# Tralee-Fenit Greenway

Section 38

Discussion Document

29<sup>th</sup> January 2021

Pedestrian flows as part of the proposal

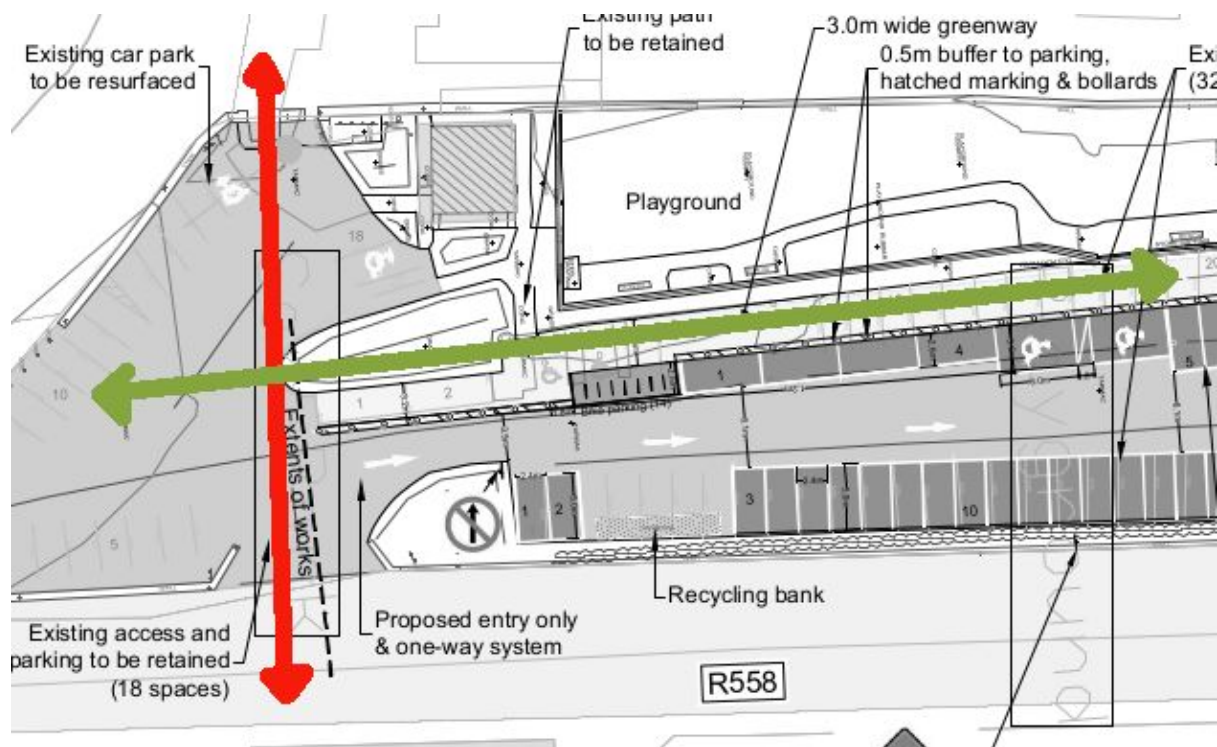
The main axis of the area runs north/south (red) the Greenway introduces a east/west axis (green)

Under the proposal the main open space is located at the opposite (East) end of the car park, this is also where the majority of the bicycle parking is located, so it would seem that the intention is for cyclists to park their bicycle here and then walk over 150m to the beach. The choice of this location as the main 'open' space makes little sense as bike parking should be as close as possible to and

We suggest flipping these areas, i.e. moving the open space from the east end to the natural focal point area at the west end of the area while relocating some car parking to the east end. The relocation of a handful of car parking bays from the entrance to Lockes Beach could

serve to transform this area into a new plaza providing a new focal area and a welcoming greenway terminus.

Semi-underground Waste System

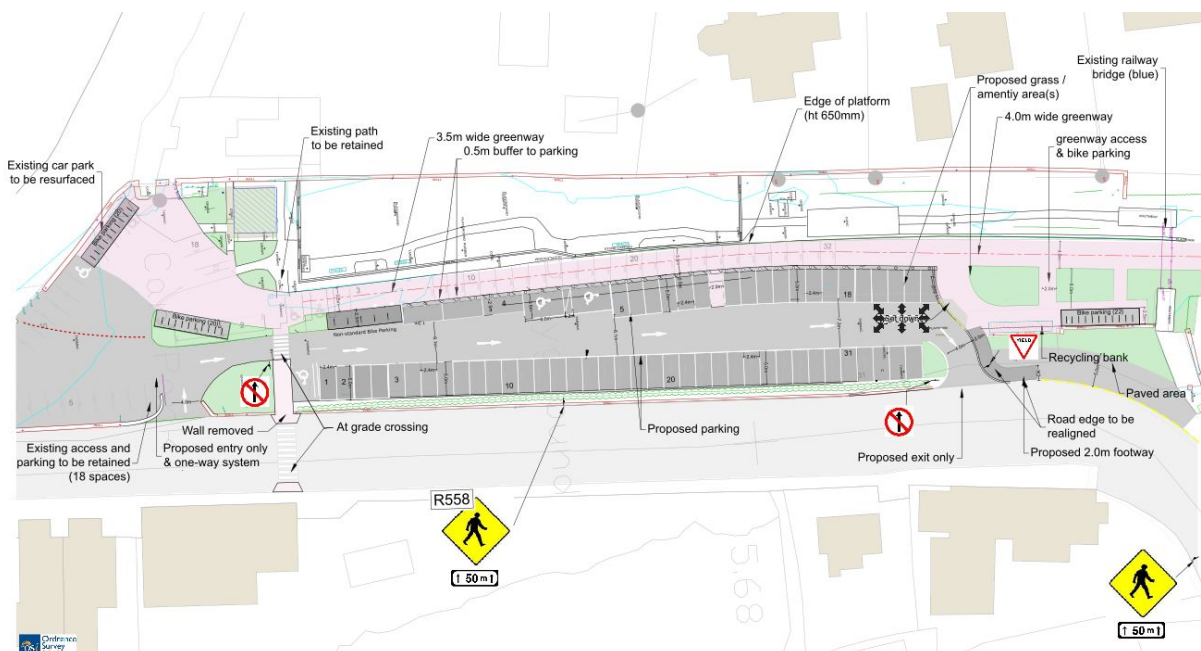
We suggest relocating the bottle bank to the eastern end and possibly installing an underground or semi-underground bin system . From a visual perspective, the bottle bank being away from the trailhead is desirable and an underground system would be much tidier and much quieter than the conventional bottle banks that are above ground. This would also create space for more bike/car parking or open space.

View from the greenway of the current junction, access to Flavin's Beach and existing cycle lane.

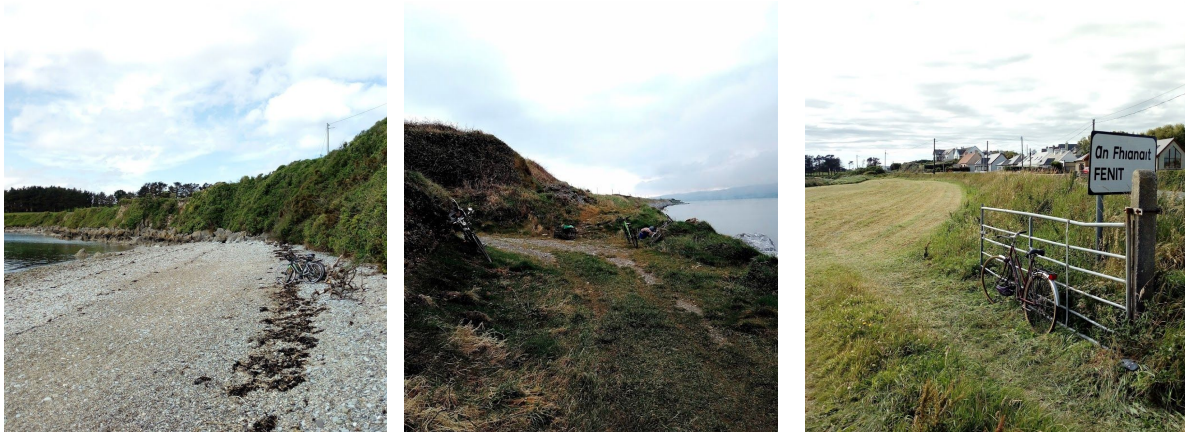
The proposal map does not indicate the current cycle path along the R558 nor does it indicate how this will link with the greenway.

This location is not only an only a point of access but also a crossing point as it is directly opposite the entrance to Flavin's Beach.

We would also suggest the provision of secure cycle parking at this location both to cater for existing users as well expected greenway traffic.

### **Exit to Spa Village**

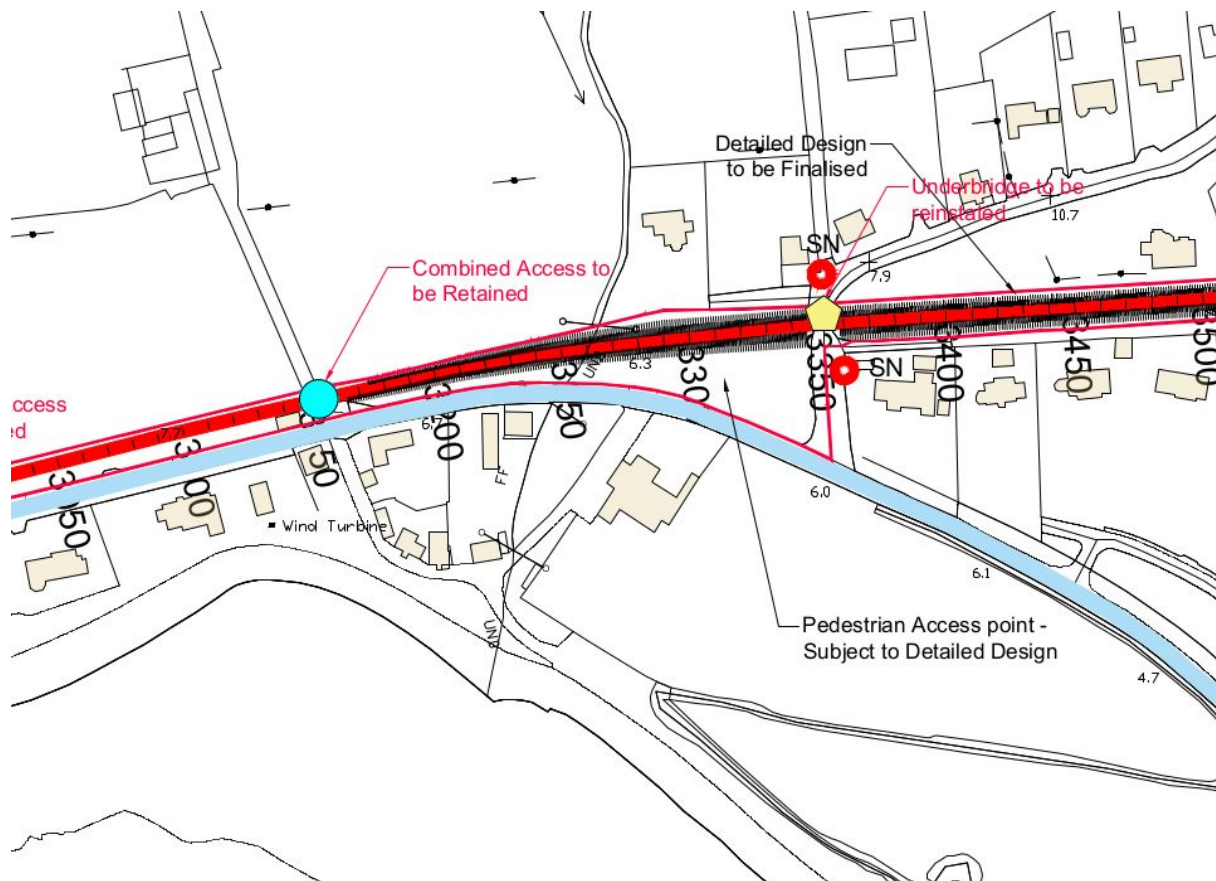
The exit at The Spa is welcome as it will connect the greenway to Spa Village and the North Kerry Way. However, the exit is at the top of the hill, and behind the apex of the bridge. Motorists travelling south towards The Spa will be unable to see people exiting the greenway and this will create a significant hazard. We suggest the narrowing of the road on the northern side of the bridge and the installation of a yield one-way system.

While possibly outside the scope of these works, further traffic calming and protective measures should be provided from this exit to The Spa village. A fully segregated shared pedestrian/cycle path is advised. Without a safe way for families, children or less experienced cyclists to access the village it will limit the attractiveness of the route, lessen the economic benefit to businesses and significantly impact the possibility of school children cycling to the national school.
